UNITED STATES PATENT AND TRADEMARK OFFICE

APPLICATION NO.	FILING DATE	FIRST NAMED INVENTOR	ATTORNEY DOCKET NO.	CONFIRMATION NO.
10/806,593	03/23/2004	Gernot Brasen	DE920030002US1	2463

Office Action Summary

DETAILED ACTION

FIG. 3

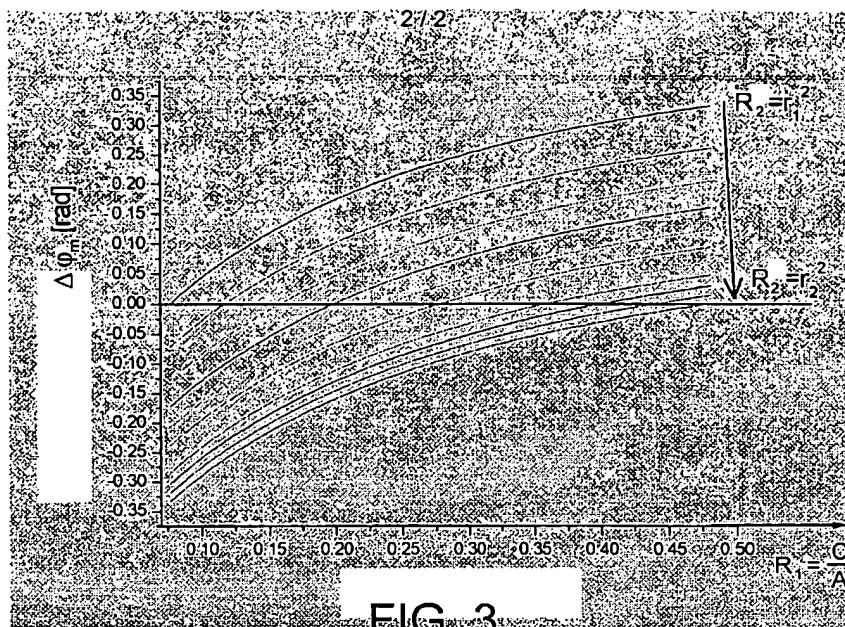
The drawings are objected to because figures 3 and 4 appear to have shading that has prohibited them from being reproduced clearly. Copies of the drawings (figures 3 and 4) are included in this Office Action. Corrected drawing sheets in compliance with 37 CFR 1.121(d) are required in reply to the Office action to avoid abandonment of the application. Any amended replacement drawing sheet should include all of the figures appearing on the immediate prior version of the sheet, even if only one figure is being amended. The figure or figure number of an amended drawing should not be labeled as "amended." If a drawing figure is to be canceled, the appropriate figure must be removed from the replacement sheet, and where necessary, the remaining figures must be renumbered and appropriate changes made to the brief description of the several views of the drawings for consistency. Additional replacement sheets may be necessary

to show the renumbering of the remaining figures. Each drawing sheet submitted after the filing date of an application must be labeled in the top margin as either "Replacement Sheet" or "New Sheet" pursuant to 37 CFR 1.121(d). If the changes are not accepted by the examiner, the applicant will be notified and informed of any required corrective action in the next Office action. The objection to the drawings will not be held in abeyance.
